SUBJECT: REQUEST FOR ADDITIONAL INFORMATION - DAVIS-BESSE NUCLEAR
POWER STATION (TAC NO. MB8953)

By letter dated May 14, 2003, you submitted a request for amendment to the Davis-Besse Nuclear Power Station Operating License, NPF-3, which would modify the Technical Specifications by allowing entry into Mode 3 operation during the current outage only with neither high pressure injection (HPI) pump capable of taking suction from the low pressure injection system trains when aligned for containment sump recirculation. The HPI system will otherwise be operable.

REQUEST FOR ADDITIONAL INFORMATION
DAVIS-BESSE NUCLEAR POWER STATION
DOCKET NO. 50-346

The following preliminary copies of LOCA response were provided at Lynchburg, VA:

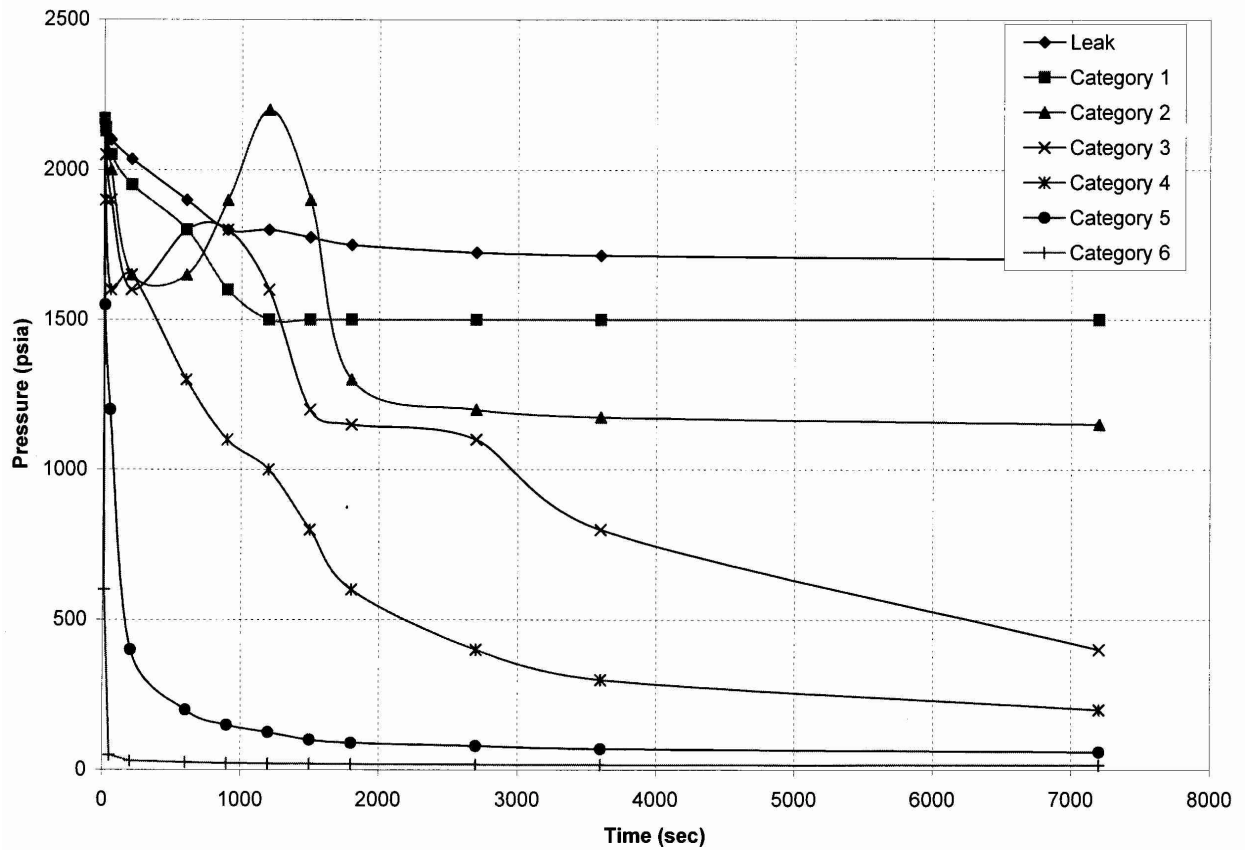
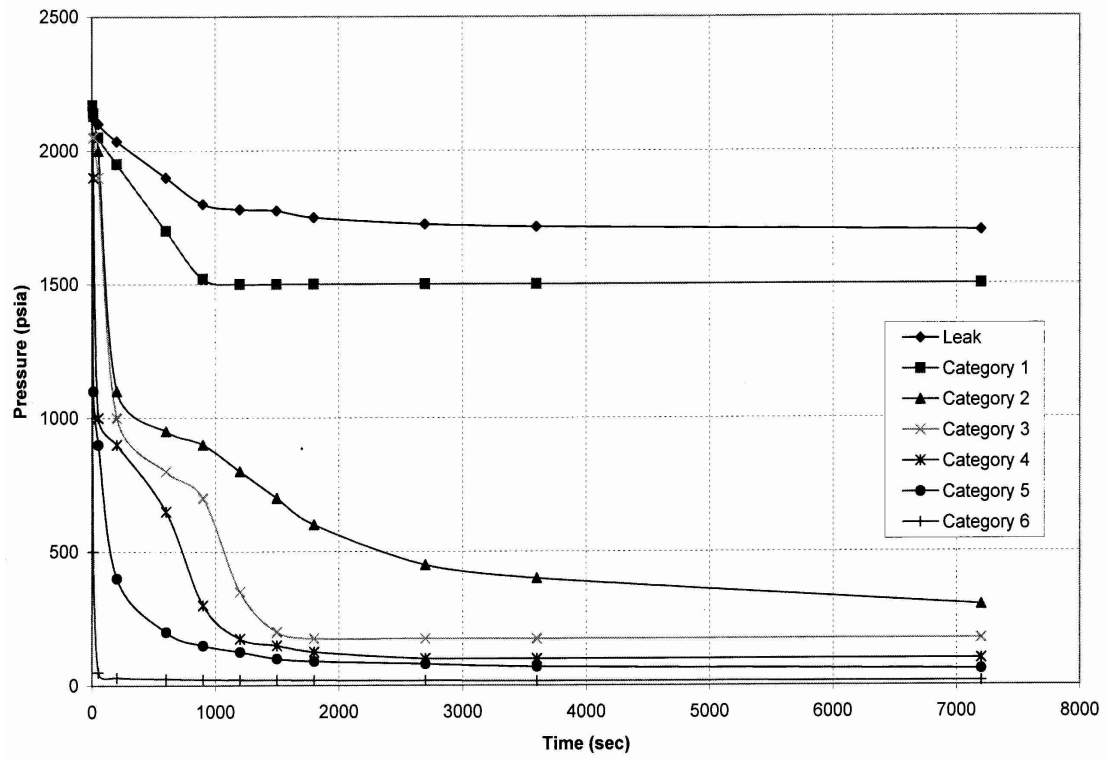
43. Provide docketed copy of the RCS pressure/time histories (full power as well as Mode 3) as supplied by FANP.

Full Power Pressure Time Histories

Mode 3 Pressure-Time Histories
